UNITED STATES PATENT AND TRADEMARK OFFICE

APPLICATION NO.	FILING DATE	FIRST NAMED INVENTOR	ATTORNEY DOCKET NO.	CONFIRMATION NO.
10/707,874	01/20/2004	Kent Kuohua Chang	9945-US-PA-1	1873
31561	7590	11/15/2005	EXAMINER	
JIANQ CHYUN INTELLECTUAL PROPERTY OFFICE			TOLEDO, FERNANDO L	
7 FLOOR-1, NO. 100			ART UNIT	
ROOSEVELT ROAD, SECTION 2			PAPER NUMBER	
TAIPEI, 100			2823	
TAIWAN			DATE MAILED: 11/15/2005

Office Action Summary	Application No. 10/707,874	Applicant(s) CHANG, KENT KUOHUA	
	Examiner Fernando L. Toledo	Art Unit 2823

Fig. 7

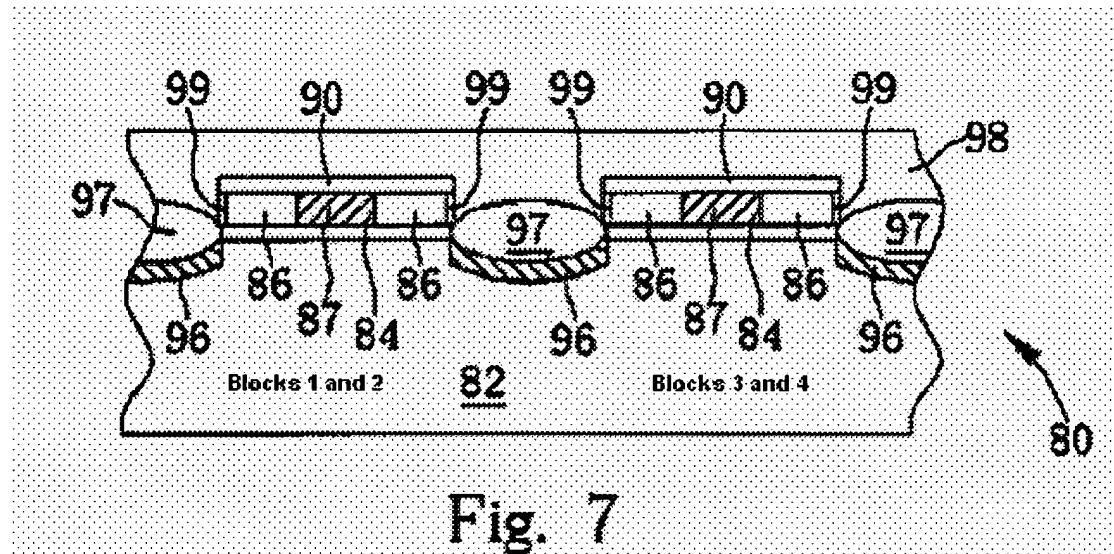
16. Applicant contests that Chang does not show more than two conductive blocks.

Examiner respectfully submits that Figure 7 of Chang shows at least 4 conductive blocks.

Figure 7 has been modified to underscore that it shows the at least 4 conductive blocks.
